Cc: Burgess, Margo; Hogan, Charlene; Clausen, Scott; Kasemets, Juri; Tupper, Rennie
Subject: De Beers Snap Lake Project - NRCAN Technical Report

Non-Technical Summary of Natural Resources Canada's Technical Comments on the De Beers Canada Mining Inc. Snap Lake Diamond Project Environmental Assessment

SNAP LAKE - TECHNICAL REPORT
submitted by
NATURAL RESOURCES CANADA

Figure 1. Mean annual air temperature for Yellowknife from 1943 to 2001 (Data from Environment Canada)
NRCan Snap Lake Technical Report - February 14, 2003

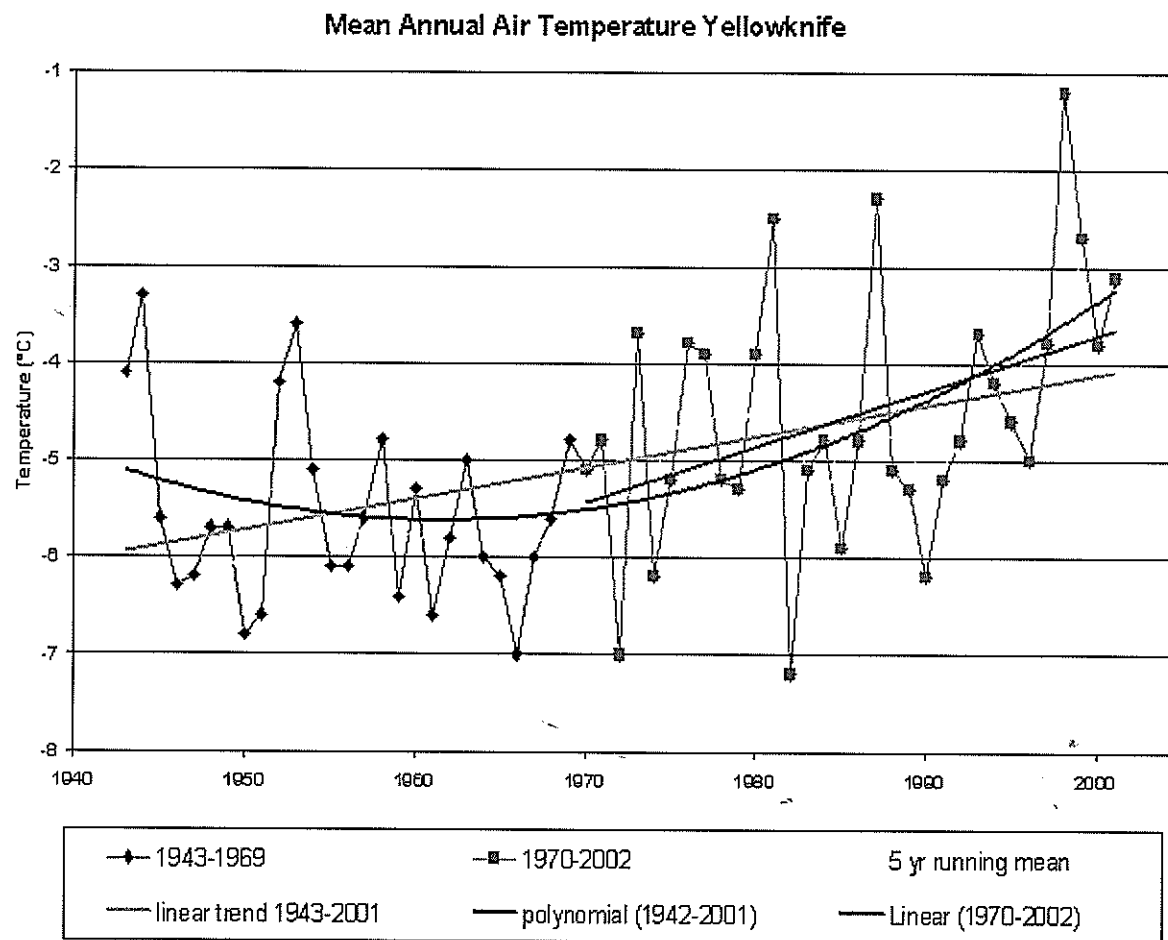
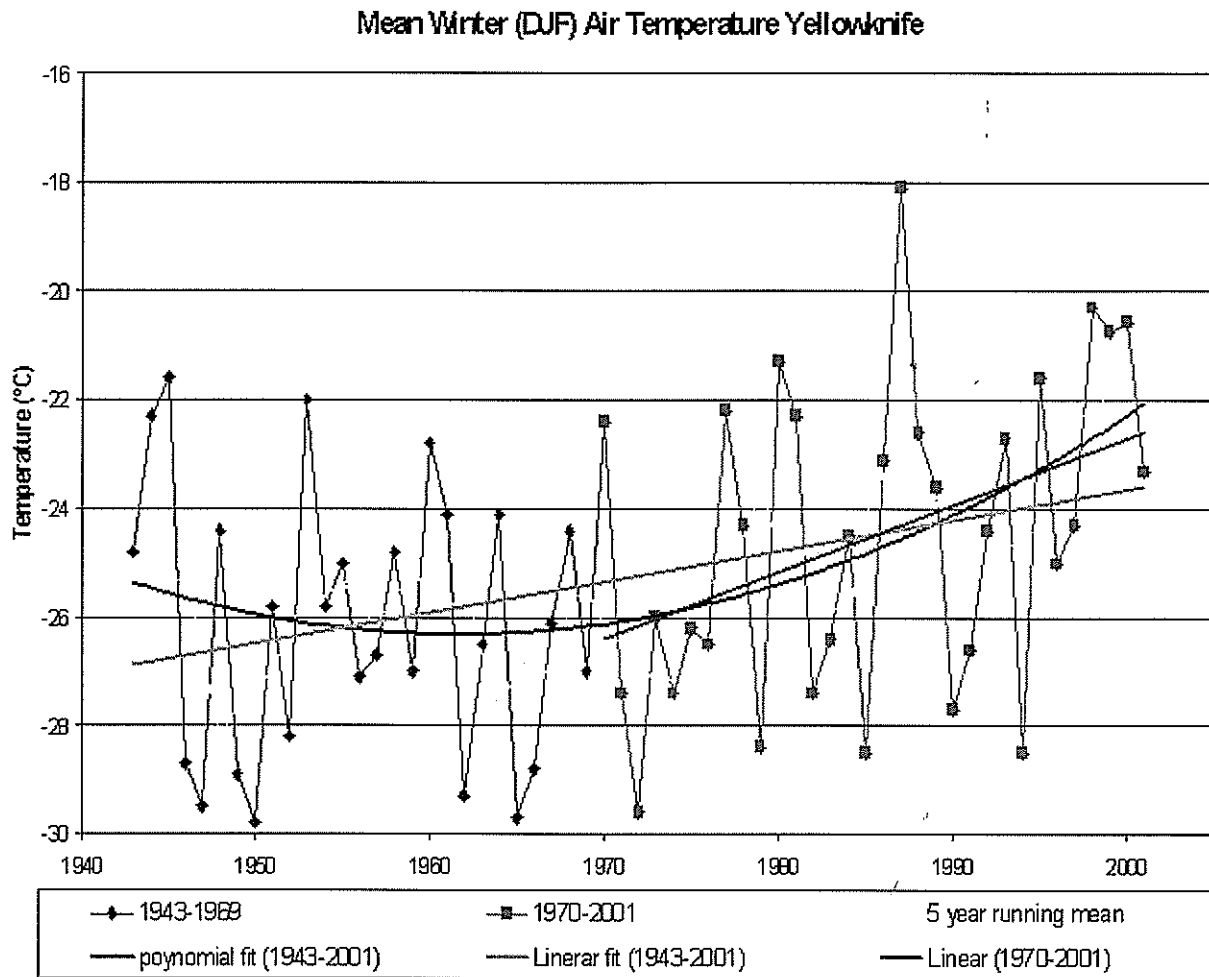
Fitting a straight line trend to a data set that is not inherently linear does not provide the best representation of the change in air temperature over time. Both the records of mean annual air temperature and the mean winter temperature for Yellowknife (Environment Canada data) show a decreasing trend from 1944 to the late 1960s to early 1970s which is then followed by an increasing trend (Figs. 1 and 2). If a low order polynomial is used instead of a linear fit, an increase in the rate of change is also observed from the 1970s to the present. A more appropriate approach would be to break the data set into two sections and determine the linear trend for both or to fit a non linear equation to the entire data set. The proponent's analysis does not consider that there is an increasing trend in air temperature (decreasing trend in air freezing index) over the last 30 years of the record and underestimates the increase in temperature that has occurred over the last 30 years (Figs. 1 and 2). The proponent's analysis therefore probably does not represent current conditions and extrapolation of this trend will likely underestimate air temperatures (or overestimate the freezing index) in future years. This could have important implications for the operating window of the road over the lifetime of the project even if traffic volumes over the last 15 years are reduced from the peak values.

The proponent should at a minimum conduct a trend analysis for the last 20 to 30 years of air temperature data to produce a more conservative estimate of the operational window of the winter road over the life of the project to consider what impact a shorter season may have on the project.
